UNITED STATES ENVIRONMENTAL PROTECTION AGENCY

Subject: Transmittal of "Port of Stockton Municipal Separate Storm Sewer Audit Report"

Port of Stockton Municipal Separate Storm Sewer System (MS4) Audit Report

Exhibit 1 – Approximate location of the Daggett Road Project Packages A, B, C, D, and E (adapted from the SWPPP for Navy Drive to McCloy Security Reroute Project Package D, dated April 13, 2007).

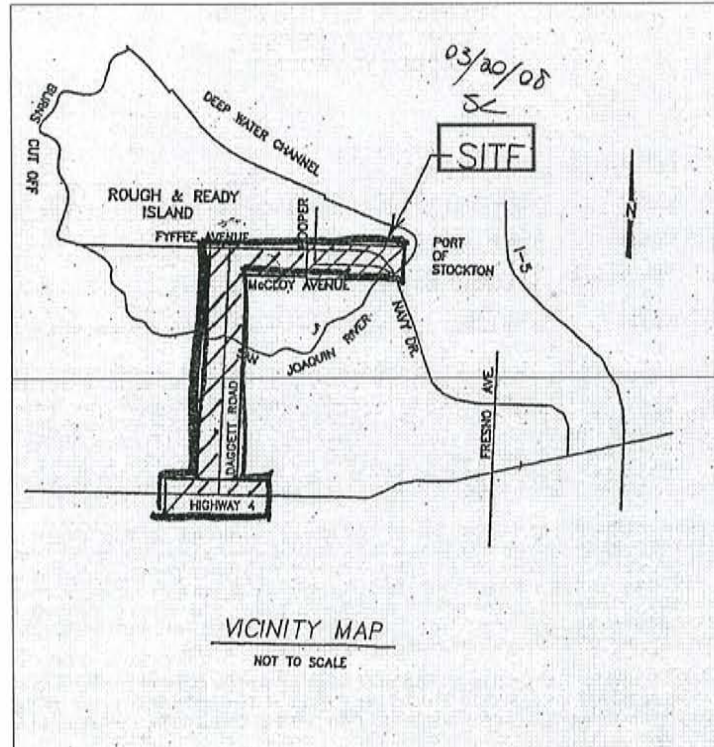
This site was a Port-owned and -administered roadway construction and improvement project along a linear length of roadway from State Route 4 to the Navy Drive Bridge spanning the San Joaquin River. The project consisted of new roadway construction, rerouting, and widening, in addition to the construction of the Port of Stockton Expressway Bridge, a new bridge spanning Burns Cutoff. The project was developed in a series of phases or “packages” under a common plan of development over time. Packages A, B, C, D, and E are within a contiguous area connected by Daggett Road, McCloy Avenue, and Fyffe Avenue (Exhibit 1). Based on Notice to Proceed documents issued by the Port, Packages B, C, D, and E were approved and constructed after the February 17, 2006, DSP compliance date (Exhibit 2, for example). It is unclear why the Port failed to identify the Daggett Road Project as a DSP project when the A-Plus tenant site triggered the DSP requirements based on the addition of impervious surfaces over time and will likely be required to implement treatment control BMPs in accordance with the DSP (Exhibit 3).

Photograph 1: An actively disturbed slope located adjacent to a drainage ditch along Navy Drive and southeast of the construction site entrance.

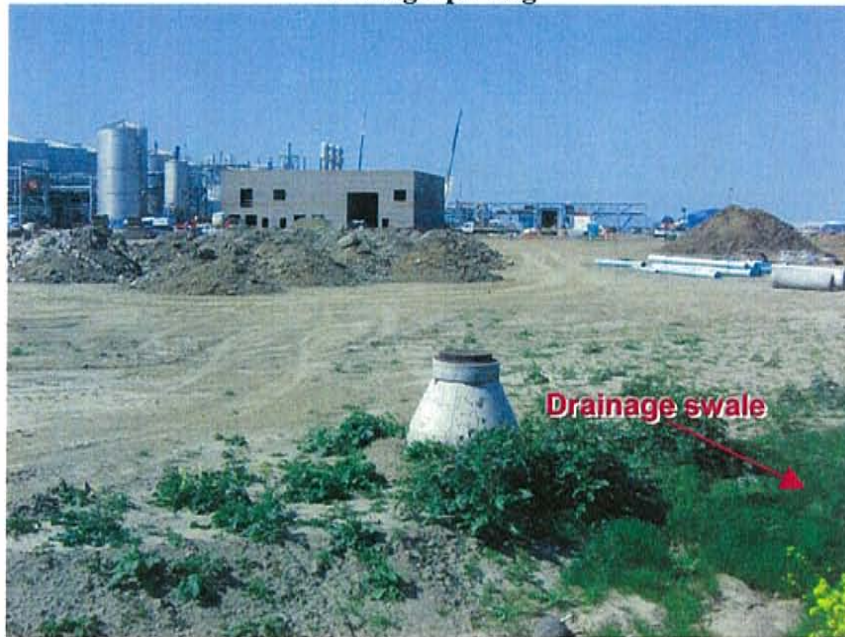
Section C.7.a.ii of the Order requires that Port inspections of construction sites ensure that sediments generated at a project site are retained on-site and that erosion from slopes and channels is controlled by implementing an effective combination of erosion and sediment control BMPs. It was observed during the audit that BMPs were not implemented to prevent the discharge of sediment from an actively disturbed slope adjacent to a drainage channel along Navy Drive and southeast of the construction site entrance (Photograph 1). BMPs were not implemented between the slope and the adjacent drainage channel or in the disturbed drainage channel itself, and the surfaces of the slope and channel were not stabilized (Photograph 2). As a result, there was a potential for the discharge of sediment from the disturbed slope and drainage channel leading to the South Ditch and East Complex Retention Basin. In addition, BMPs had not been implemented between a large expanse of disturbed soils, a number of uncontrolled soil stockpiles, and the adjacent drainage swale (Photographs 3 and 4). Evidence of erosion, including rill formation on the slope of the drainage swale (Photograph 4), was observed. The Port Construction Site Inspector explained that the drainage swale that encompasses the site discharges through a storm drain outfall into the drainage channel along Navy Drive (Photograph 5), leading to the South Ditch, East Complex Retention Basin, and ultimately the San Joaquin River. BMPs must be installed, inspected, and maintained to prevent the discharge of sediment from the aforementioned disturbed areas of the site to the drainage channel along Navy Drive. Moreover, the Port must ensure that

Photograph 2: BMPs were not implemented between the slope and the adjacent drainage channel or in the disturbed drainage channel itself, and the surface of the slope was not stabilized.

sediments generated at the Pacific Ethanol project site are retained on-site and that erosion from slopes and channels is controlled by implementing an effective combination of erosion and sediment control BMPs.

Photograph 11: View of Lowe's Distribution Center equipment maintenance shop.

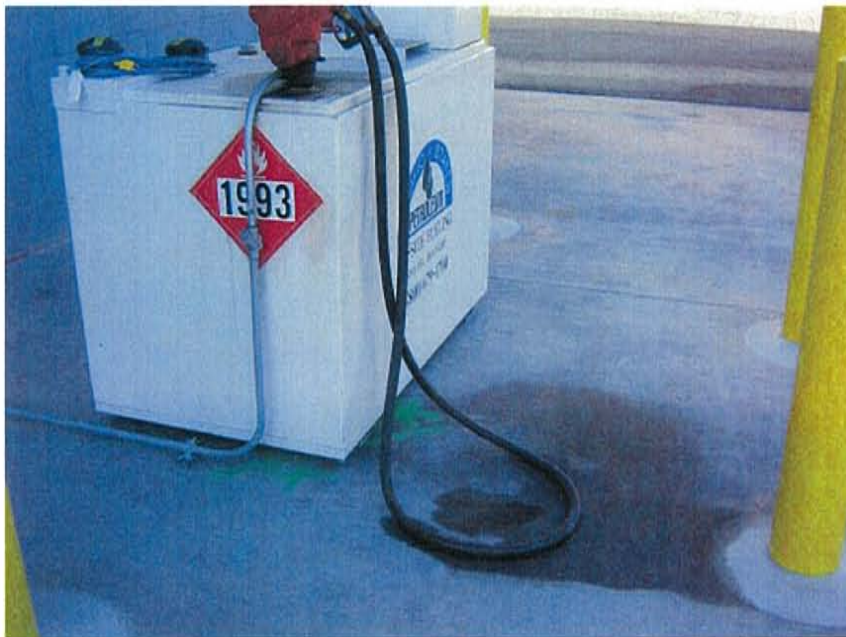
The Lowe’s Distribution Center is a completed commercial project consisting of a warehousing and distribution facility for home improvement goods and building and construction materials. Section C.14.a.v of the Order defines the parking lot category as “parking lots exposed to rainfall that are 5,000 square feet or more, or with 25 or more parking spaces.” The site includes a newly constructed equipment maintenance (Photograph 11) and fueling (Photograph 12) shop and approximately 20 acres of

Photograph 12: View of Lowe's Distribution Center fuel storage tank located adjacent to the maintenance shop.

impervious parking improvements (Photographs 13 and 14). As a result, this project likely qualifies as a Priority Development Project under both the commercial and parking lot categories. Based on Port records provided during the audit, the Lowe's HIW, Inc., lease approval date (September 5, 2006) and construction start date occurred after the February 17, 2006, DSP compliance date (Exhibit 4) and therefore should have been reviewed and conditioned for compliance with the Development Standards.

Photograph 13: Impervious parking improvements at the Lowe's Distribution Center (looking north).

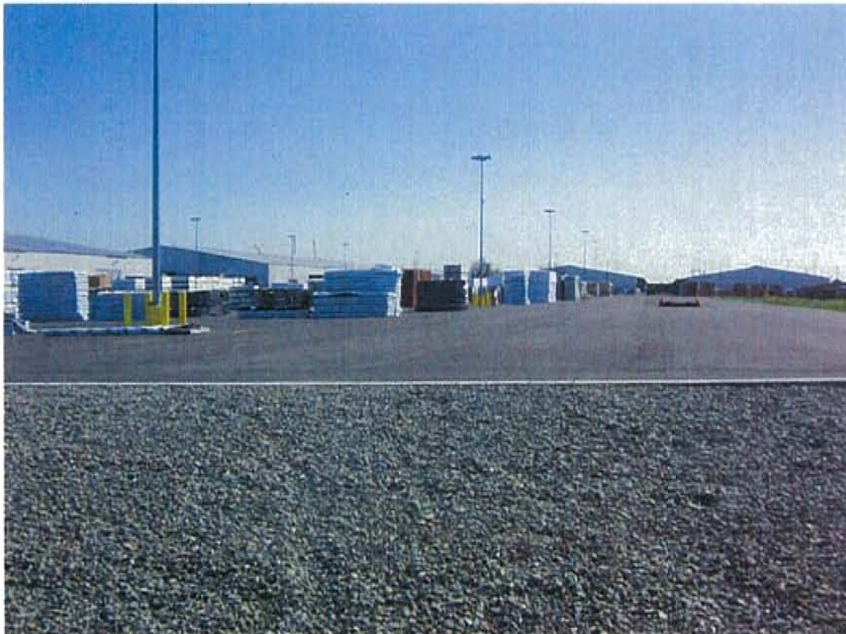
Photograph 14: Impervious parking improvements at the Lowe's Distribution Center (looking east).
